SERVICE BULLETIN NO. MSB-AE50R-003

Engine affected: **AE50R Series**

Sub Assembly Rotor & Pulley – R1A-91-100-000 (E_R1 B 034)

Figure 1: Scrub screw assembly

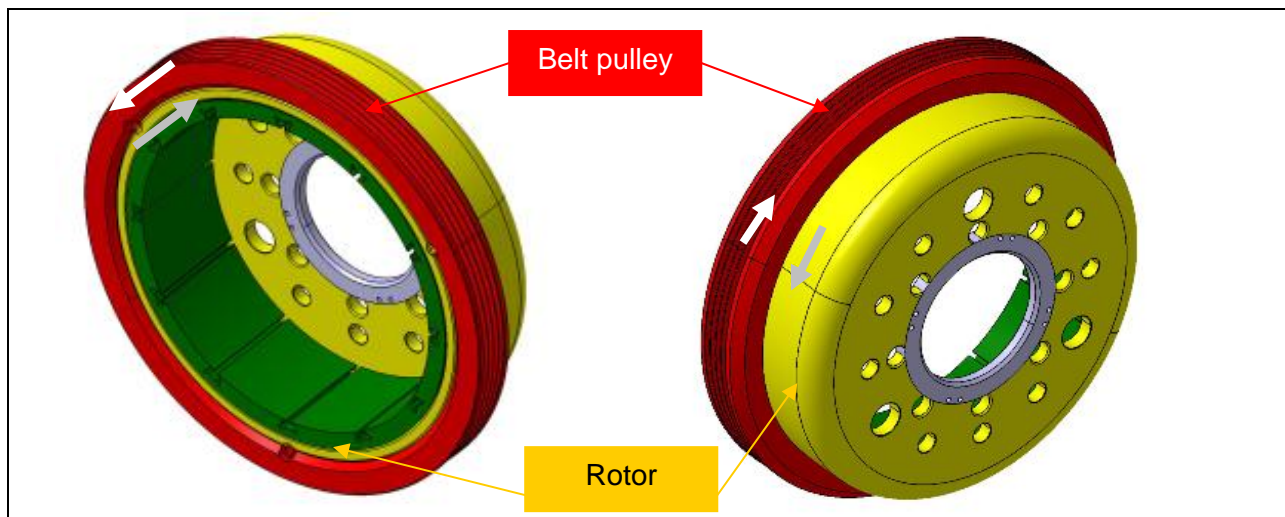
- ⇒ Identify if a twist between the belt pulley and the rotor is evident or grub screws got loose [Figure 1] or are missing.

- ⇒ Remove all grub screws [Figure 1] in the generator rotor assembly.
- ⇒ Clean the holes with ACETON, use new scrub screws M4x5 (DIN 913).
- ⇒ Screw in the grub screws as far as possible.
- ⇒ The new scrub screws are 3mm shorter than the original assembled scrub screws. Use LOCTITE "Hysol" 3450 two component epoxy adhesive. Fill the thread above the scrub screw consistent with the adhesive to avoid unbalanced mass during operation [Figure 3]. Make sure that the adhesive enters the thread and cured according the product description sheet before operation.
- ⇒ Remove overlapping adhesive.
- ⇒ Clean the working area.

Figure 4: Slip mark indication

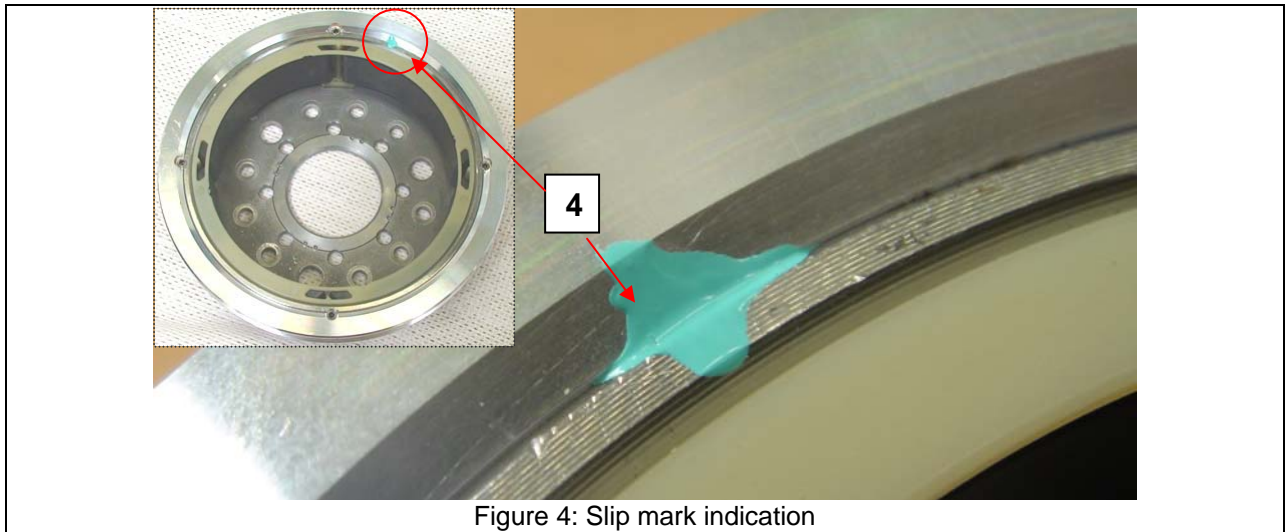
- ⇒ Identify if a twist between the belt pulley and the rotor is verifiable evident.
- ⇒ If no movement has been identified apply an adequate slip mark [Figure 4] on the visible belt pulley and rotor surface to monitor possible movement during operation.

It is required to monitor the slip mark during scheduled maintenance to identify possible movement between the belt pulley and the rotor.
